Ivins City Staff Report
City Council Meeting 12/18/2014

Agenda Item: Approve expenditure for change order to Contract 14-07 Central Ivins Storm Drain Outfall Repair

CONTRACT 14-xx: CENTRAL IVINS STORM DRAIN OUTFALL REPAIR

RESTORATION AND MITIGATION PLAN

TYPICAL CHANNEL SECTION
NTS

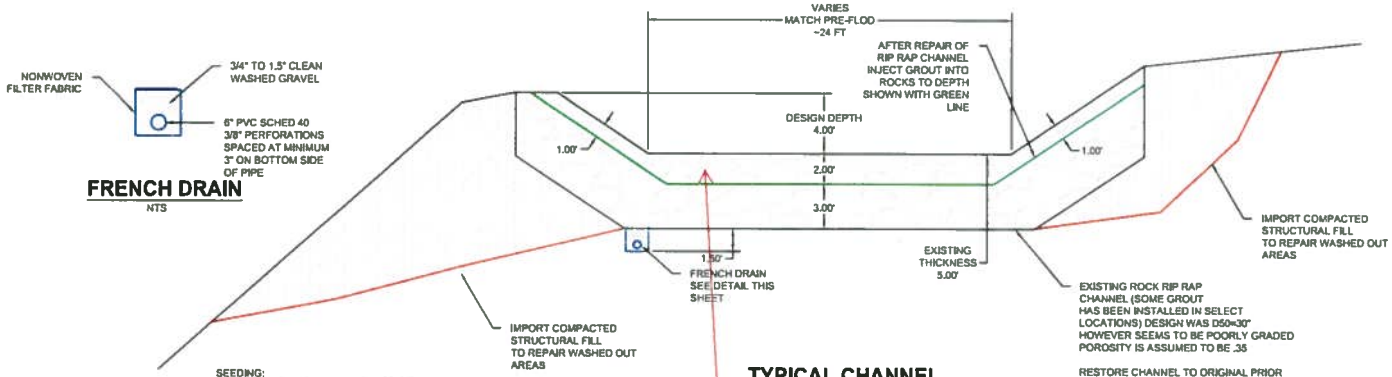
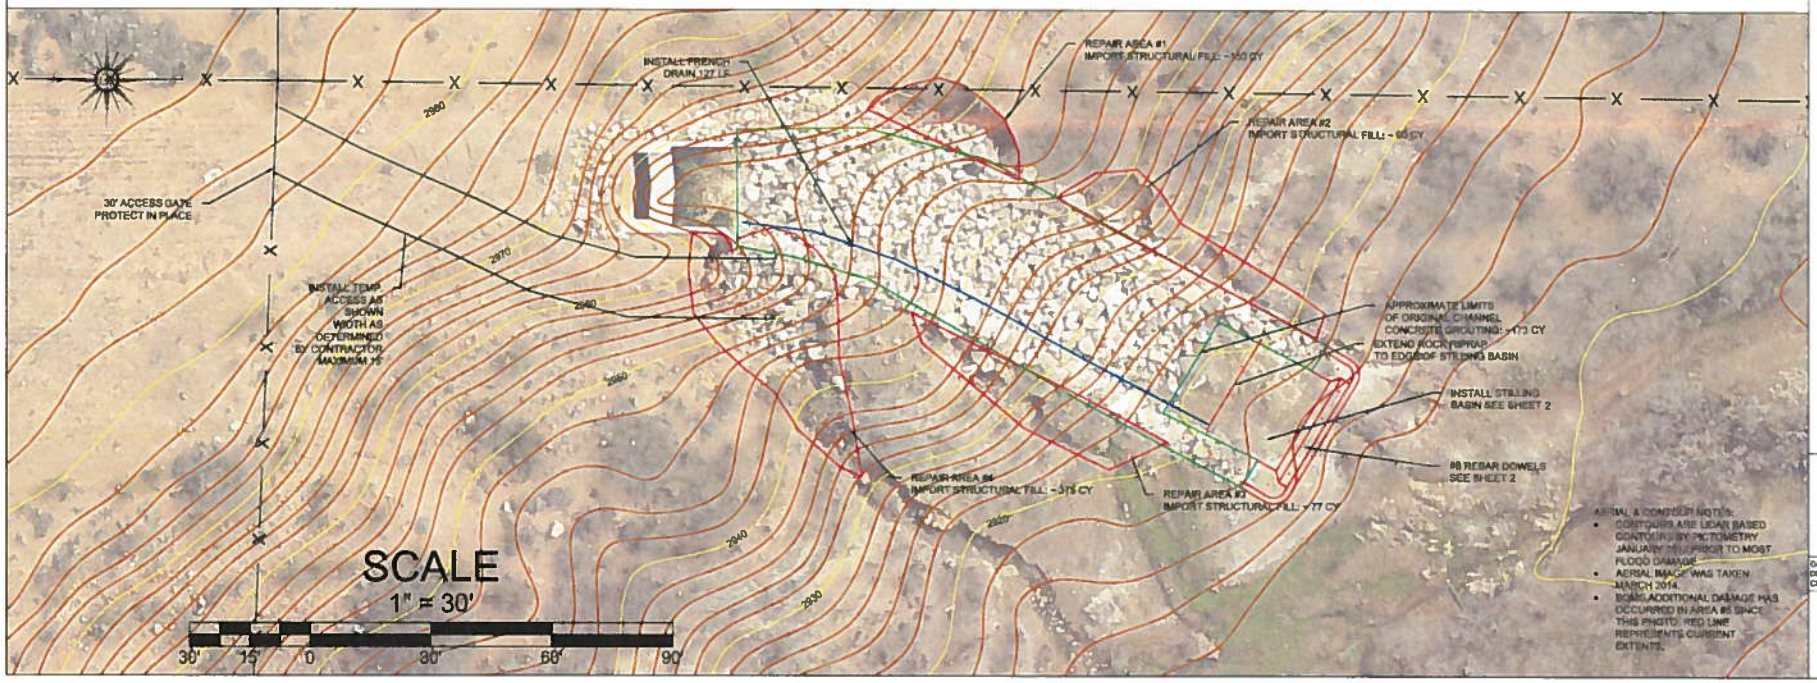
On October 16, 2014, City Council approved $90,000 for Contract No. 14-07 Central Ivins Storm Drain Outfall Repair. The plan was to repair the outfall by partially filling the five foot thick rock armoring with three feet of concrete grout. The work was completed according to this plan, however, there appears to be some concern that concrete grout is not protecting the underlying soil from scouring because the perpetual water flow that discharges from the storm drain disappears through a short section of the outfall and then resurfaces lower. It is possible that this water is not reaching subgrade however; it seems to be a risk not worth taking while federal monies are available for the project. NRCS is willing to expand the scope of the project to grout the rest of the spillway.

Area to filled with 100% concrete grout

Based on unit prices and estimates of the additional concrete grout that is needed, staff estimates that the cost to install the additional grout will be $25,000. This request is for council to authorize $30,000 in case our estimates are low.
